# SERVICE BULLETIN SPSB009

SUBJECT: SUPPLIER/VENDOR RECALL OF PS70104 HOUSINGS (METAL FLEX HOISING INC)

STATUS: MANDATORY INSPECTION AND REPLACEMENT OF RECALLED HOUSINGS

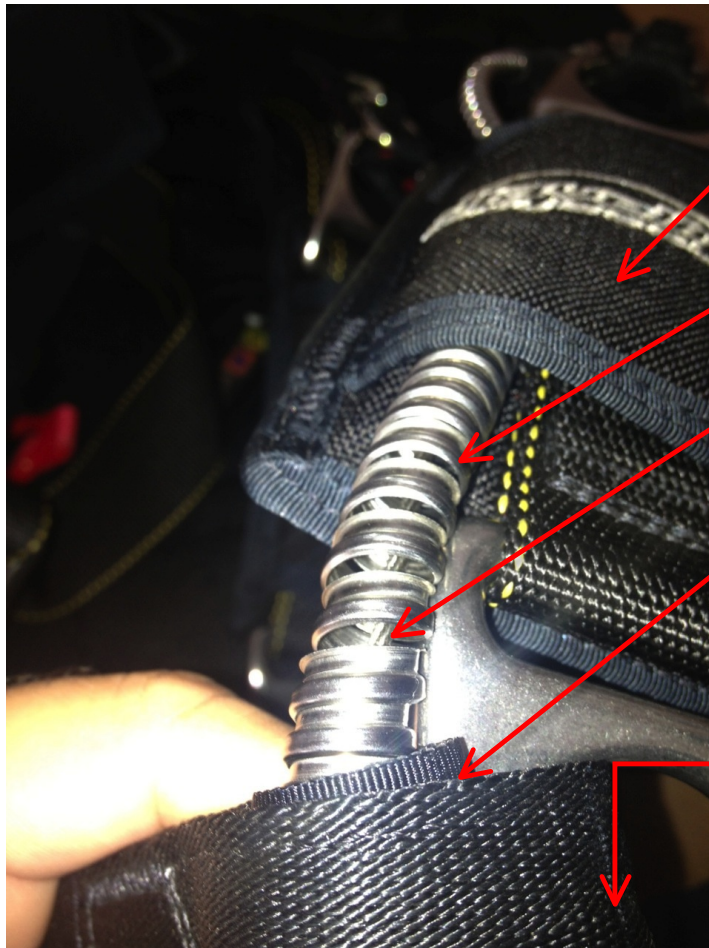
**Who can inspect:** Anyone can inspect this area. See photos below.

**WEARERS LEFT SIDE:**

RING COVER

RESERVE RIPCORD HOUSING (LOWER END)

SEPERATED HOUSING (FOR REFERNCE)

CHEST STRAP BUFFER

CHEST STRAP

**What to inspect:** All JA101-XX harness container systems listed in table above. Inspect Reserve Ripcord housing.

If the serial number is listed in the above table, inspect the available exposed reserve ripcord housing. Locate the lower end of the housing, which is clamped to the Main Lift Web, just above the reserve ripcord pocket. Inspect the exposed length of housing from the clamp upwards; ensure that the coil has not separated/unraveled. Be sure to inspect the section that is routed through the chest strap.

A. **HOUSING FOUND TO BE INTACT (GOOD):** The rig may continue to be jumped with periodic monitoring until the next repack cycle or earlier elective replacement. However this housing must be replaced at the next repack cycle. See <http://www.sunpath.com/support/HousingReplacement.pdf> for instructions for your rigger to complete the replacement of the housing.

B. HOUSING FOUND TO BE SEPERATED/UNRAVELLED (BAD): The housing must be replaced before the next jump by a certificated senior or master parachute rigger (or foreign equal) or the manufacturer. See <http://www.sunpath.com/support/HousingReplacement.pdf> for instructions for your rigger to complete the replacement of the housing or instructions to send your system back to the manufacturer.
